SUB-002496-2023

West Yacht Basin Subdivision

WEST YACHT BASIN SUBDIVISION

APPLICATION NUMBER 3 DATE July 20, 2023

DETAIL SITE PLAN

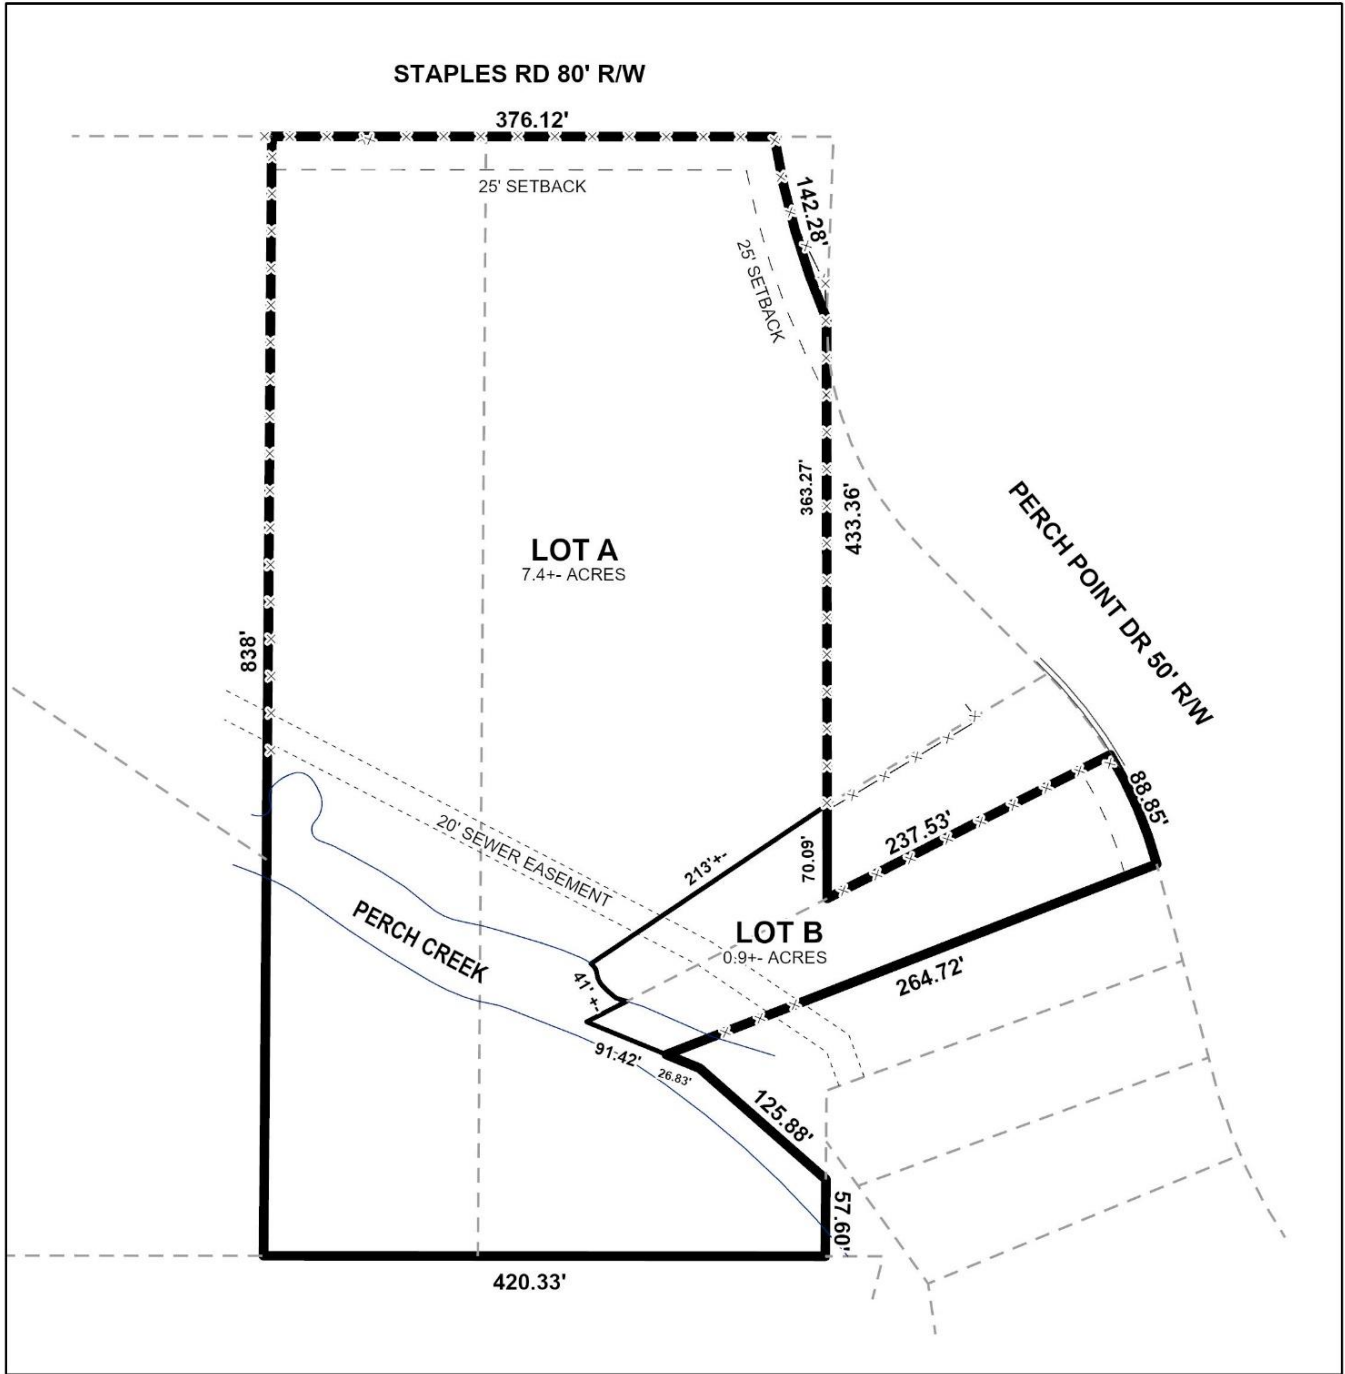
- B. Provide and label the monument set or found at each subdivision corner.
- C. At the NW corner of LOT B there needs to be a distance label (monument to corner) or show/label the monument set. The unmarked corner is shown to be at the water's edge.

- D. There are no monuments or reference monuments shown for the 34' +/- distance for LOT B. Also, need to provide a distance from the monument found and shown along to old lot 2 property line.

- E. Provide the distance from the "RECOV. ROD & CAP" along the south/east property line of lot 2.
- F. Show the entire "water's edge at time of survey" line on LOT B. The south end is not shown or is hidden by text.

- G. Show and label all flood zones. New maps went into effect on June 5, 2020.
- H. Email a pdf copy of the FINAL SUBDIVISION PLAT and LETTER OF DECISION to the Engineering Dept. for review at land.disturbance@cityofmobile.org prior to obtaining any signatures. No signatures are required on the drawing.

Proposed Lot B would exceed the maximum width-to-depth ratio as recommended by Section 6.C.3. of the Subdivision Regulations. As the corresponding section of the previous Subdivision Regulations was waived for the similar 2021 approval, a subsequent waiver would seem in order.

The plat indicates a 20-foot sanitary sewer easement across the site. Therefore, a note should be required on the Final Plat stating that no structures shall be constructed or placed within any easement without permission of the easement holder.
